*City of Albuquerque*  
*Environmental Planning Commission*

*Staff Report*

| <b>PROJECT#:</b>             | PR-2019-002284                                                                                                                                                                                                                                                                                                                                                                                                                                                                                                                                                                                                                                                                                                                                                                                                                                                                                         |
| <b>APPLICATION:</b>          | Major Amendment to a Site Plan – EPC

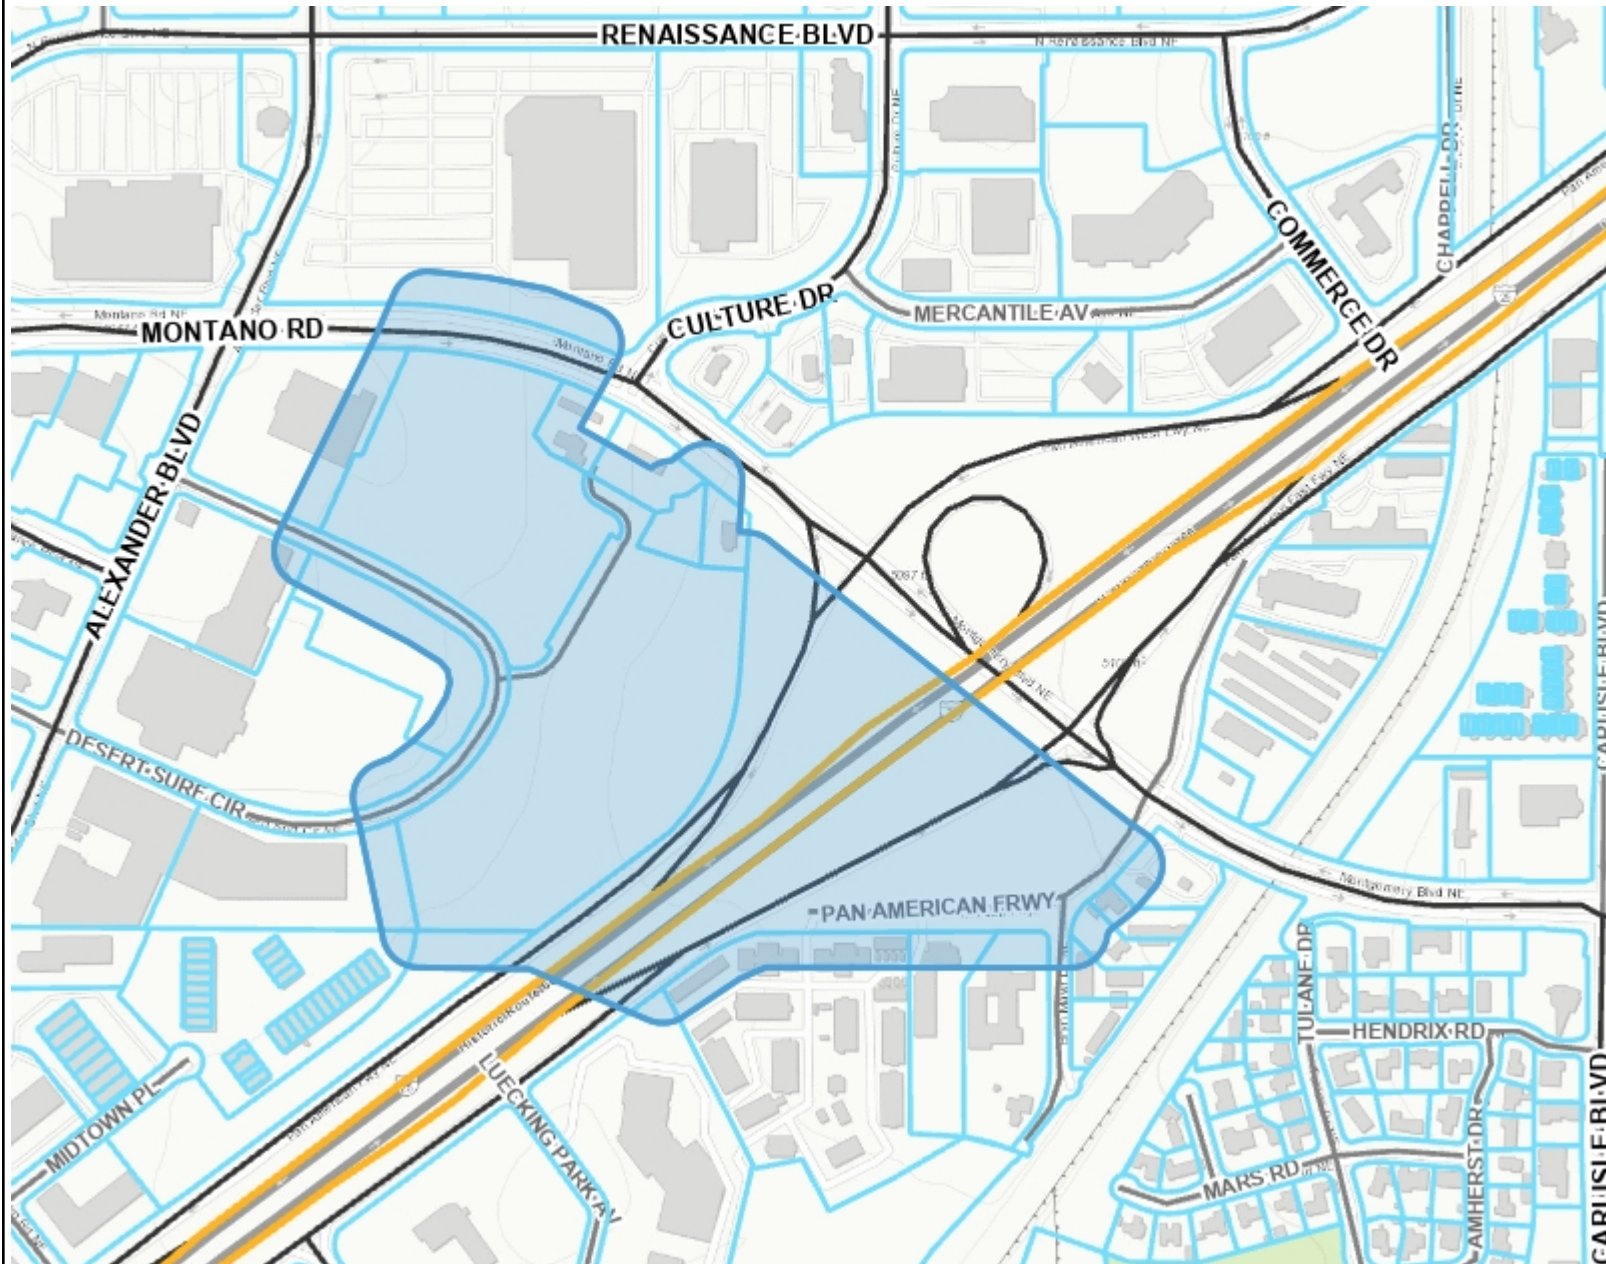
A variance of 60-feet or a redesign to remove 60-SF is required.

- Option 1: Staff suggest moving the tower to be a Freestanding sign adjacent to Montano. Monument/freestanding signs are allowed within 3-feet of the property line (IDO Table 5-1-4).
  - A Monument Sign is considered a Freestanding sign. In this case area requirements for Freestanding signs must be met and the following variances are still required:
  - The electronic signs count as **four electronic signs**.
  - The ticket booth electronic sign counts as **one electronic sign**.

- Therefore, the applicant is requesting a total of **FIVE electronic signs**. Only one electronic sign is allowed per premise and a Variance-EPC requesting 4 additional signs will be required.
- Variance to the area of signage.
- Option 2:
  - Request a variance of 22-feet to the building height allowed in the NR-C zone district for this location of the building. Note that this height would be limited to the tower only.
  - Variance to electronic sign total
  - Variance to area of signage.

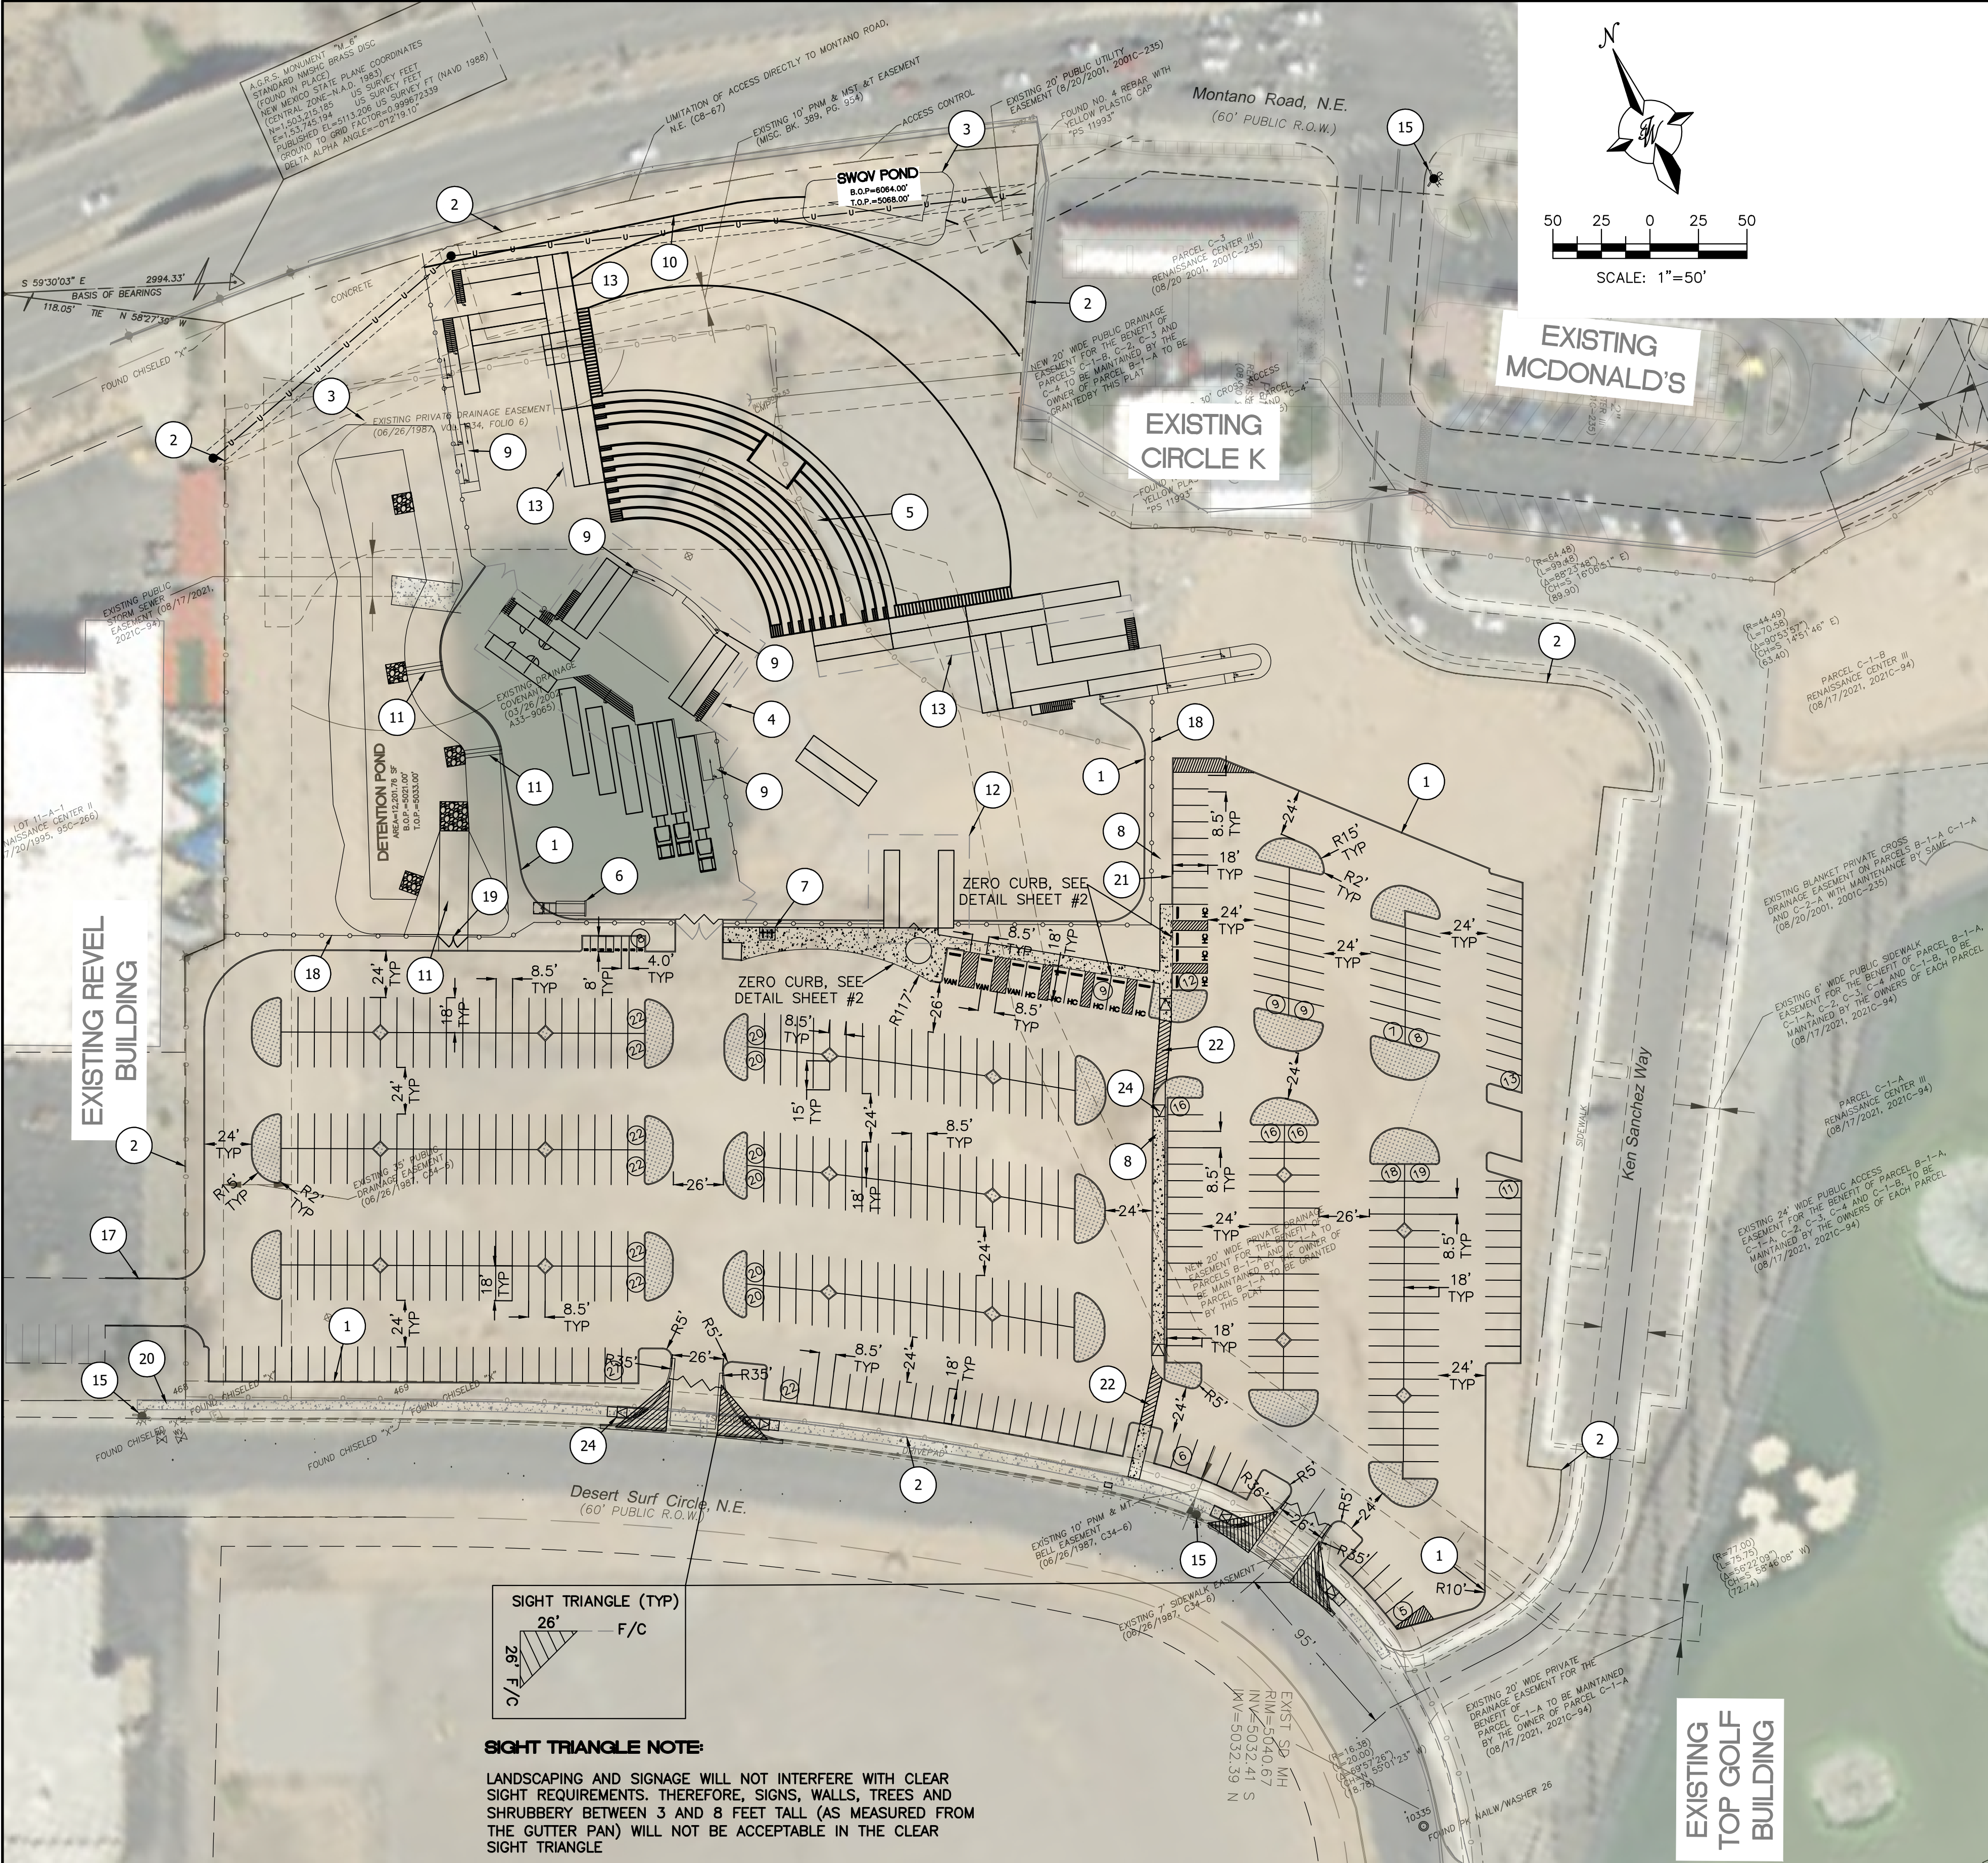
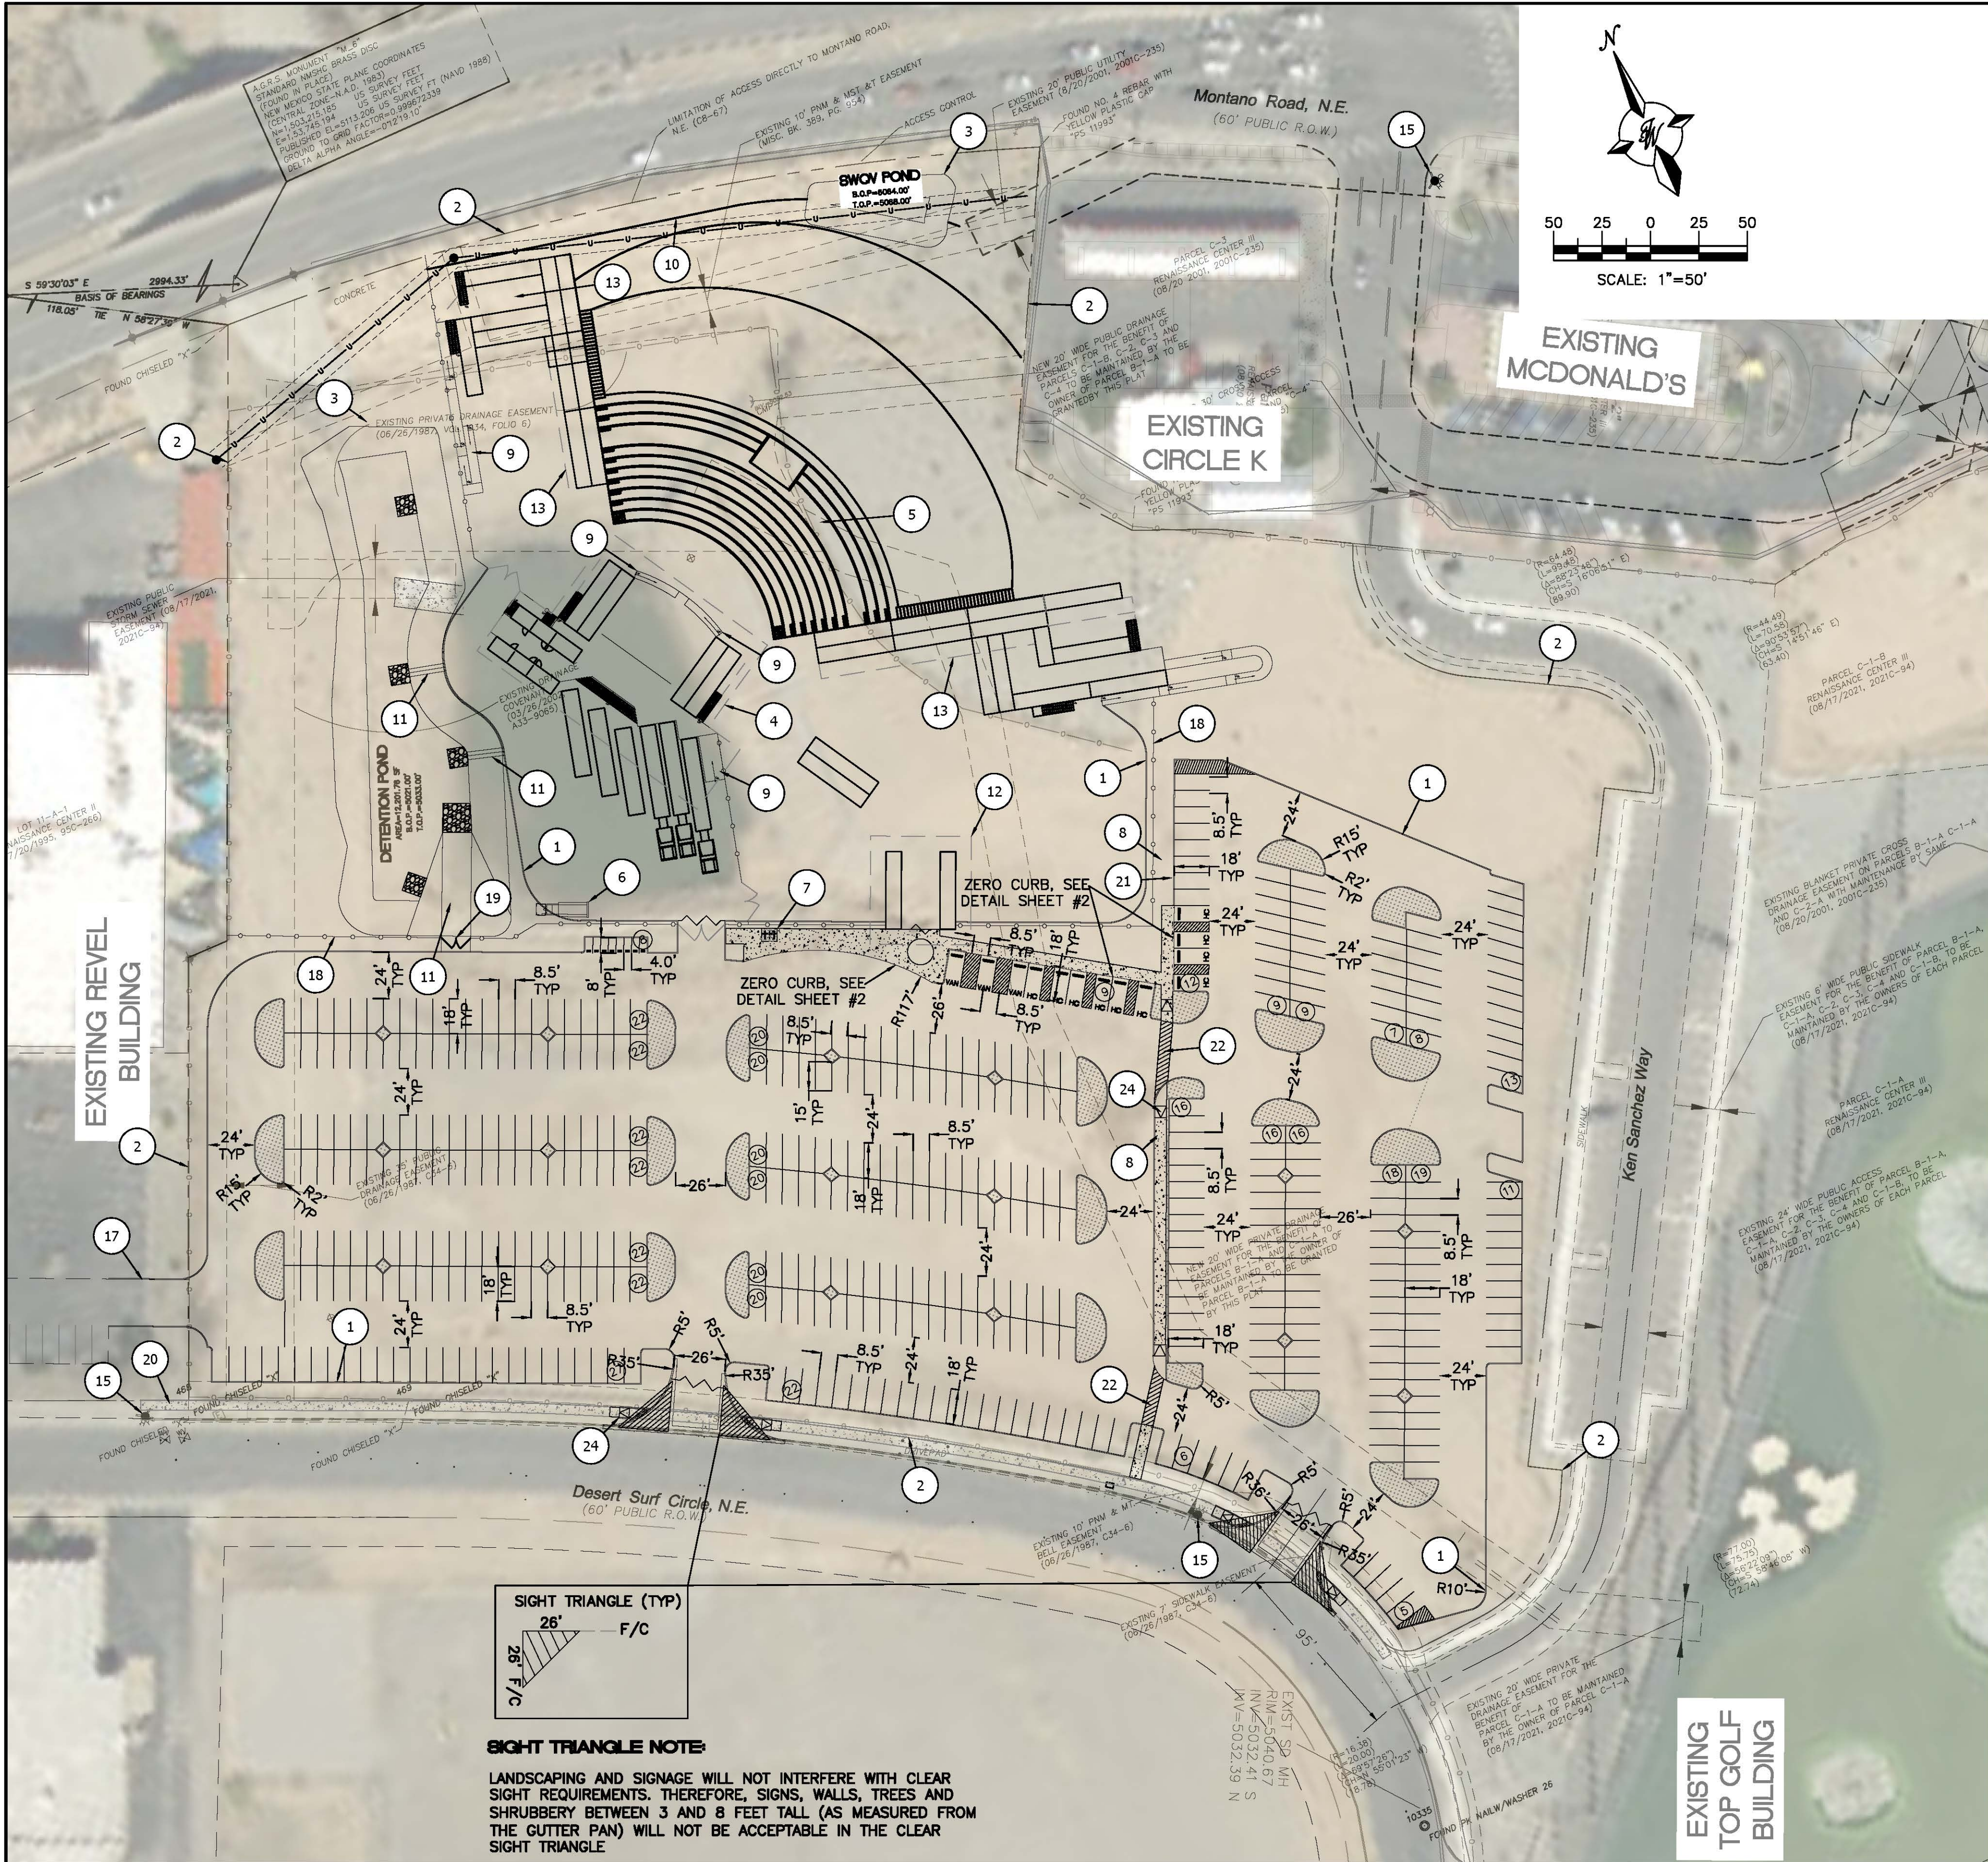
1. Total Lot Area differs from Site Data on Sheet #1 – Make both the same total.
2. Please make sure information provided on the Landscape Calculations match the information on the Site Data on Sheet 1. Staff can not verify the landscape calculations are correct.
3. Planting Beds, indicating square footage of each bed
4. Landscaped buffer areas provided; dimensions – label clearly that it is a landscape buffer, square footage and percent (specify clearly on plan)
5. Please provide a table or list that includes the street length and street tree calculations (required and provided) for each street.
6. For Buffer Edge Requirements Please see IDO 14-16-5-6(E)(5) Area of Change Next to Area of Consistency and Table 5-6-5: Edge Buffer – Development Area Summary

1. Please include a cover page depicting the entire 24 acre parcel and its boundary. The 9 acres highlighted. Then make the cover page sheet #1 and the site plan sheet #2.
